DEVELOPMENT REVIEW BOARD REPORT

Freddy's Steak Burgers 55-DR-2016

Request: Request approval of the site plan, landscape plan, and building elevations for a new restaurant with approximately 3,150 square feet of building area, outdoor dining, and drive through service, all on a 0.5-acre site.

19 OVERALL SITE PLAN (CONTEXT PLAN) WITH AERIAL OVERLAY

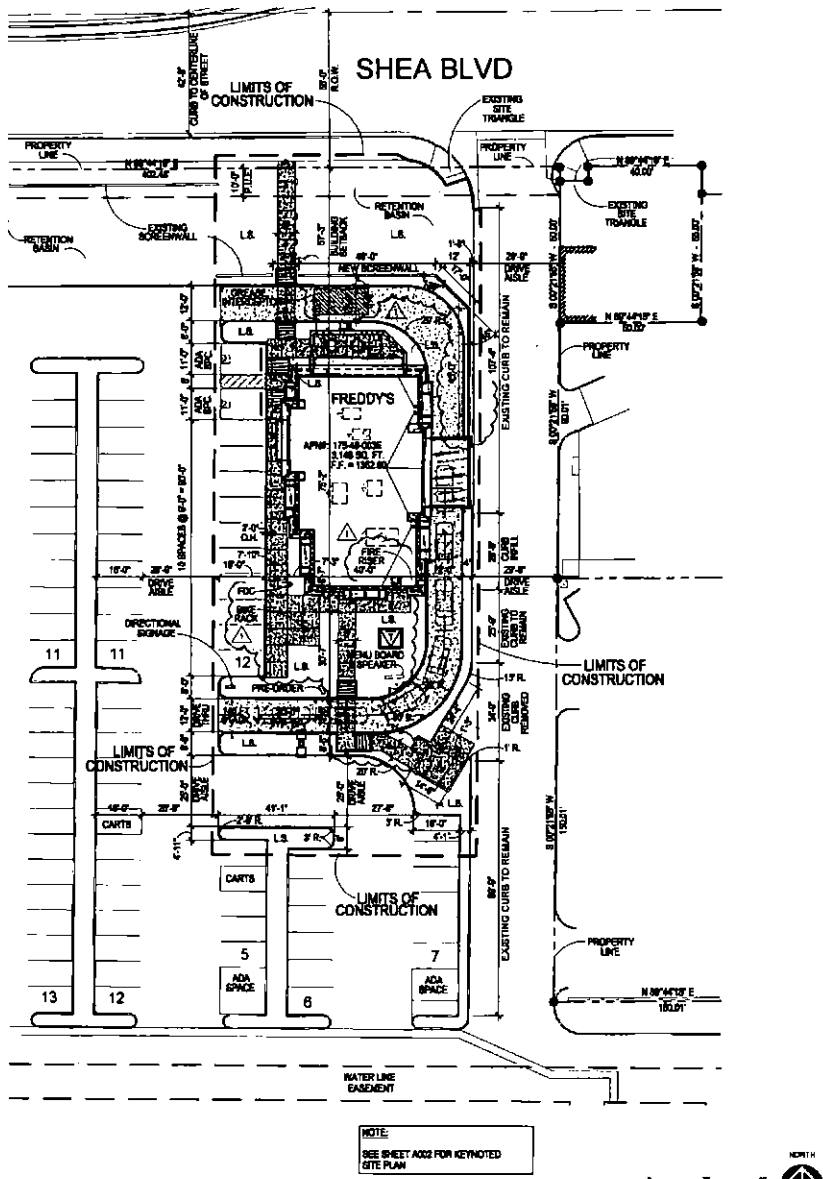
- C. Revise the northern portion of site plan so that the screen walls at the northwest corner of the site will be extended in order to screen the parking spaces and maneuvering aisles from view along the Shea Boulevard frontage, per Zoning Ordinance Section 10.402.

7 NORTH ELEVATION

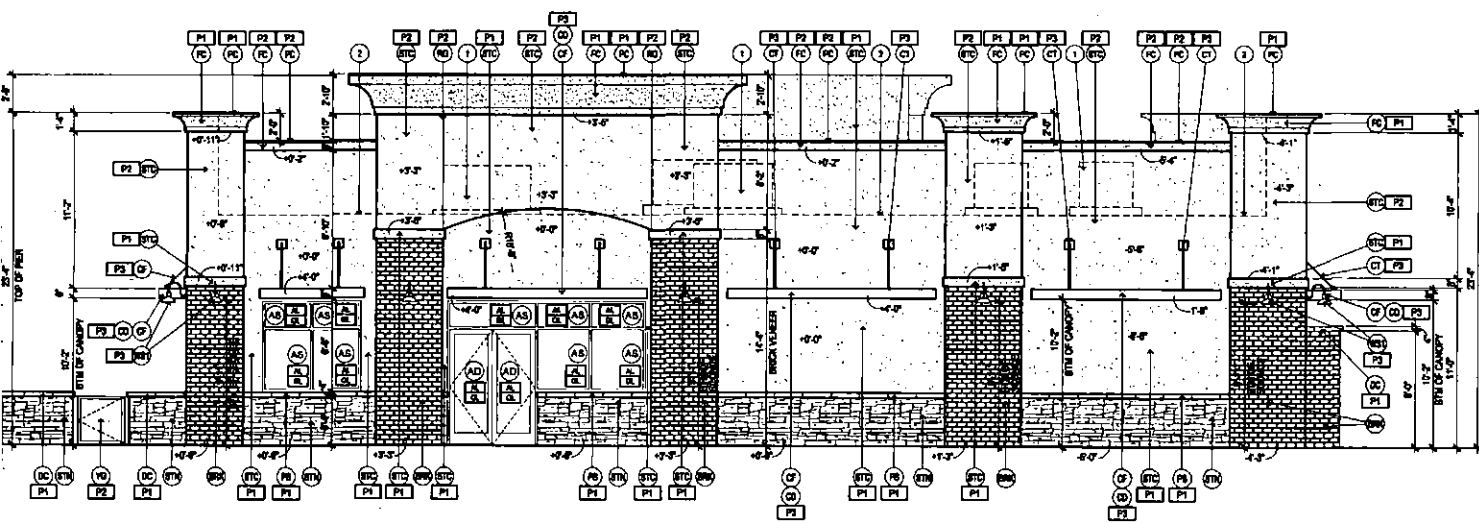
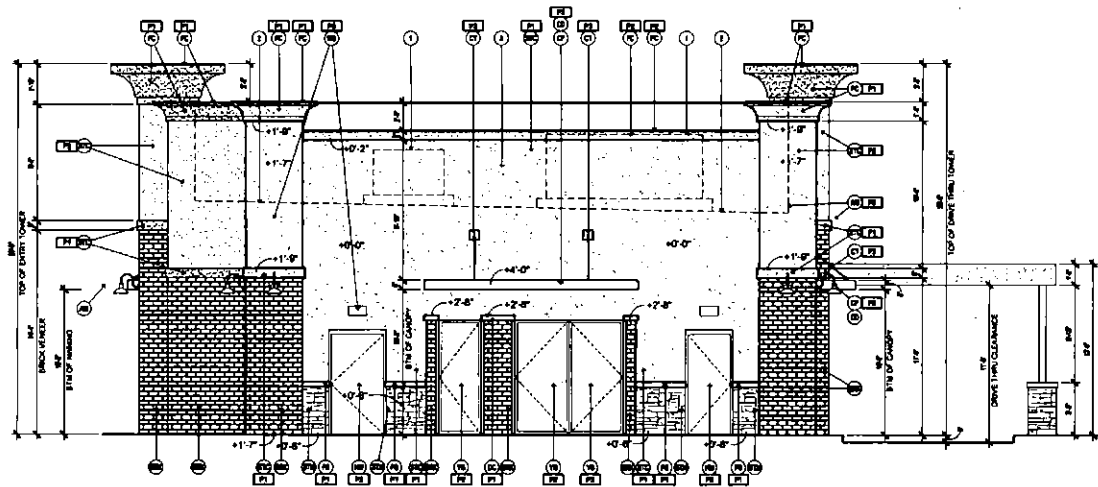
- G. All fixtures and associated hardware, including poles, shall be flat black or dark bronze. At time of final plans, the applicant shall revise the gooseneck lighting from 'Brite Red' to a flat black or dark bronze finish.
9. All exterior luminaires shall meet all IES requirements for full cutoff, and shall be aimed downward and away from property line except for sign and landscape lighting.
10. Incorporate the following parking lot and site lighting into the project's design:
